APPLICATION NO.	FILING DATE	FIRST NAMED INVENTOR	ATTORNEY DOCKET NO.	CONFIRMATION NO.
10/010,149	11/12/2001	Robert F. Evans	FCI-2580/C2977	7215
7590	01/15/2004			
Woodcock Washburn LLP				
46th Floor				
One Liberty Place				
Philadelphia, PA 19103				
			EXAMINER	
			HARVEY, JAMES R	
		ART UNIT	PAPER NUMBER	
		2833

Office Action Summary	Application No. 10/010,149	Applicant(s) EVANS, ROBERT F.	
	Examiner James R. Harvey	Art Unit 2833

DETAILED ACTION

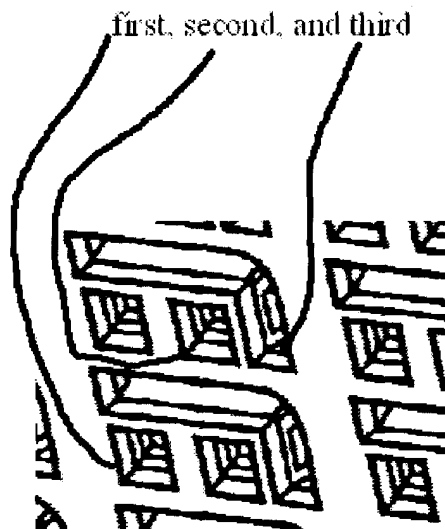
of signal contact pins 96, each pair of signal contact pins located in a plane substantially orthogonal to the ground plane (see examiner's figure).

-- In reference to claim 23, Kline shows (see examiner's figure) the columns are arranged in repeating patterns of first, second, and third columns and the first and second columns are spaced farther apart than the second and third columns.

-- In response to applicant's argument (page 10, lines 12-15) concerning that Kline does not disclose or suggest an electrical connector having each pair of signal contact pins located in a plane substantially orthogonal to the ground plane, the examiner disagrees. Kline does show an electrical connector having each pair of signal contact pins 96 located in a plane 96P (see examiner's figure) substantially orthogonal to the ground plane 84P (see examiner's figure).
